Addendum No.: 4

Date of Addendum: May 4, 2020

Prudence Crandall Museum Renovations  
1 South Canterbury Road  
Canterbury, CT  
BI – RR – 28

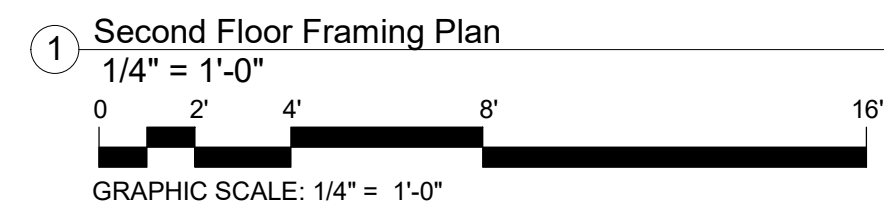
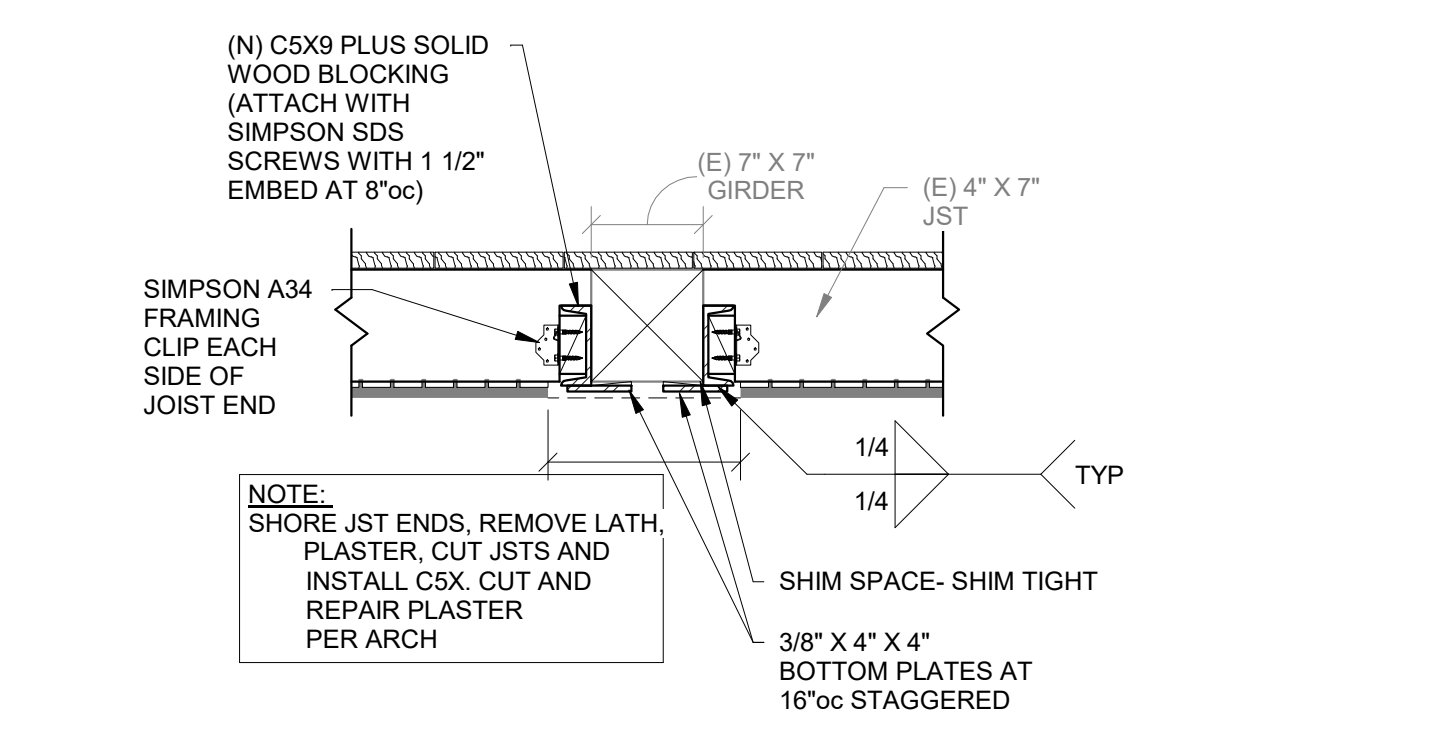
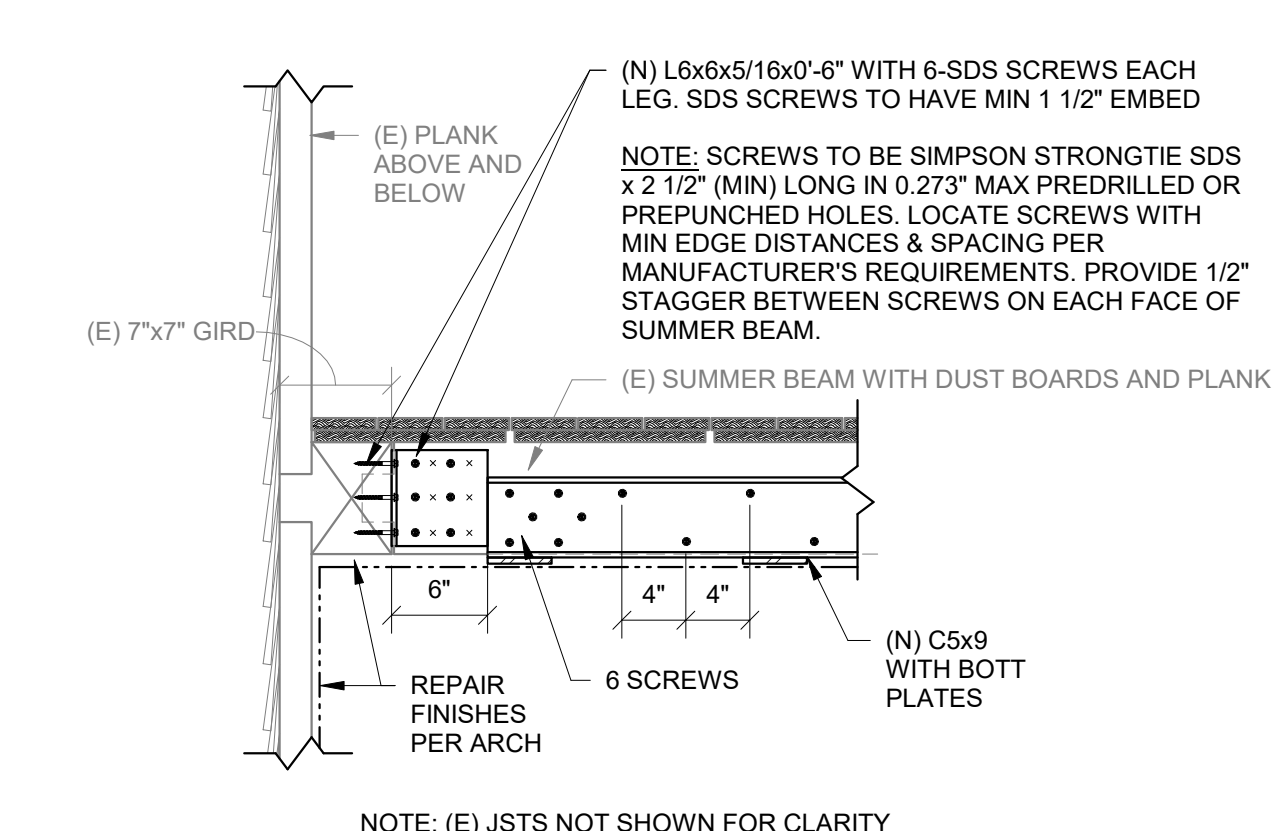
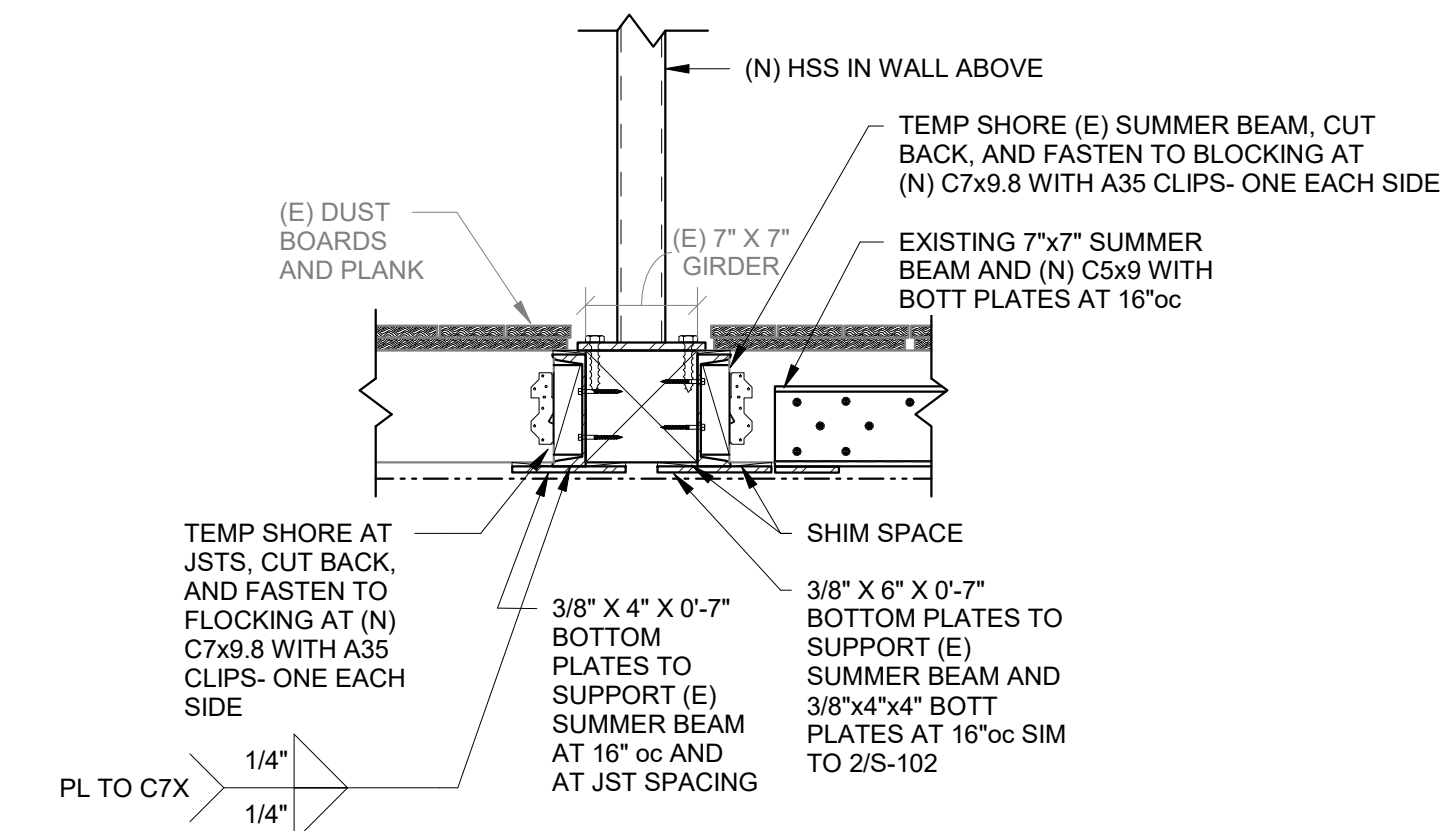
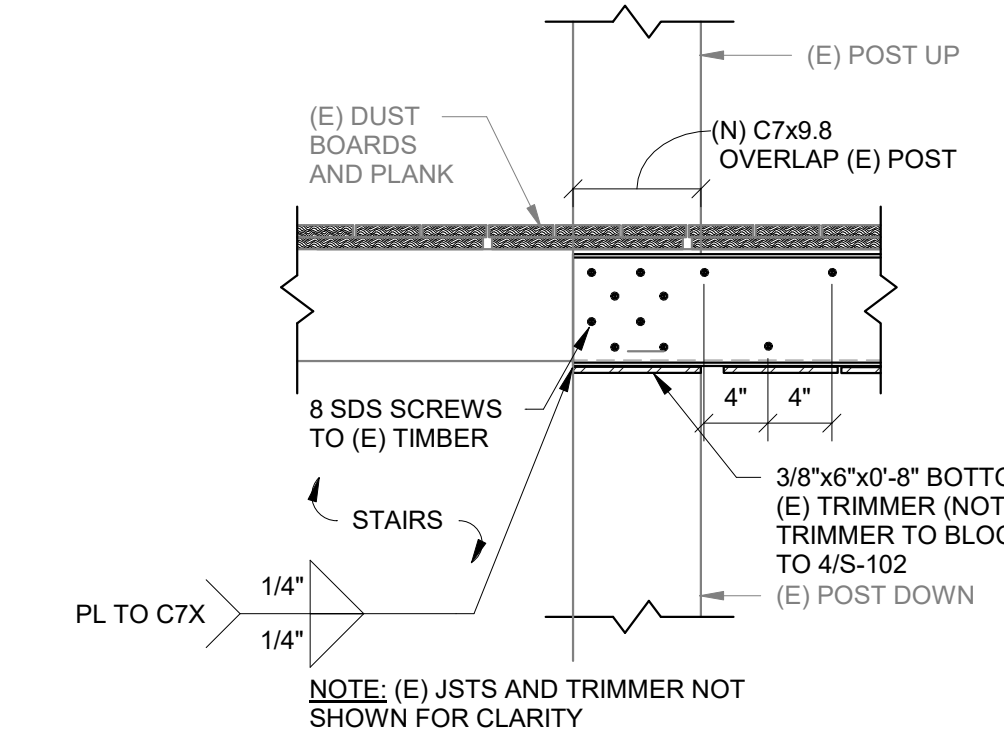
**Question 2:** *Dwg S-102, details 2, 3 and 4 call for a 3/8 plate to be welded to the bottom flange of the C5 and C7 channels at 16" OC. This is a very old house and the beams are sure to have sagged over the centuries. Is it the intent of the engineer to try and jack the beams level or to shim the beam[s] to the 3/8 plate. If the beams have sagged 1" or more the bottom row of holes in the channels will not engage the wood beams. So that we can make sure that it works in the field, we need to know what the engineer's intention is.*

**Question 3:** *Drawing S-102 calls for a 3" pipe down at gridline E1. Drawing S-101 does not show a 3" pipe at E1. Drawing S-103 shows a representation of a pipe at E-1 with no call out. Please clarify if this pipe goes up or down, or both, or none?*

**RESPONSE:** It is not the intention to jack or remove existing deflections. The intent is to stabilize the existing deflections in place. Contractor to field measure existing framing to ensure holes are located to engage existing framing. Welded plates are intended to transfer load. Holes and screws are not intended for load transfer and may be modified based on field measurements and engineer approval.

**RESPONSE:** Column should extend from ridge down to foundation. See revised structural drawings S-100, S-101, S-102, S-103, S-104, dated April 30, 2020, attached.
